Access Compliance Report

Public Rights-of-Way

(Curb Ramps)

| Intersection ID: 27314 | Main Street: CHARTER_HILLS_RD | Cross Street: WILD_DOVE_LN | Location: SW |

| ADA ID: 965F62CAC14A | Ramp Type: PerpDiag | Initial Pass/Fail: Fail | Overall Compliance: No |

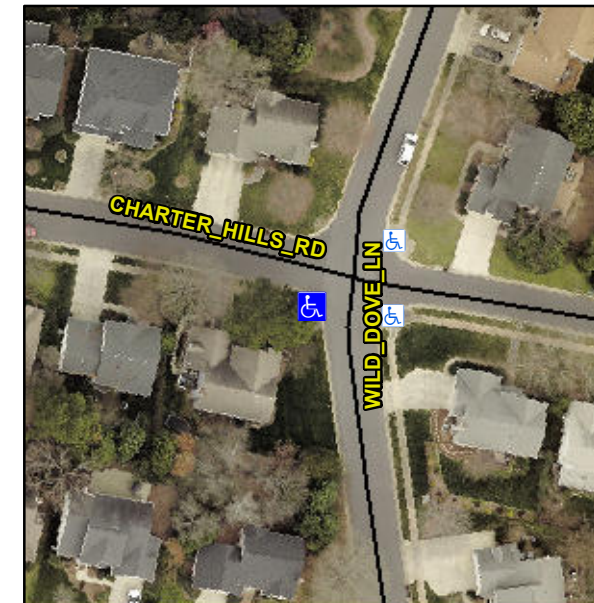
Remove & Replace Curb Ramp With Two New Directional Ramps or Equivalent.

Not Found, R304.5.1, R304.5.3

| Compliance | Description | Data | Compliance | Description | Data |
|------------|-----------------------|-------|------------|-----------------------------|------|
| N/A | Ramp Length (in) | 94.0 | Yes | Ramp Slope (%) | 5.5 |
| No | Ramp Width (in) | 39.0 | No | Ramp XSlope (%) | 4.1 |
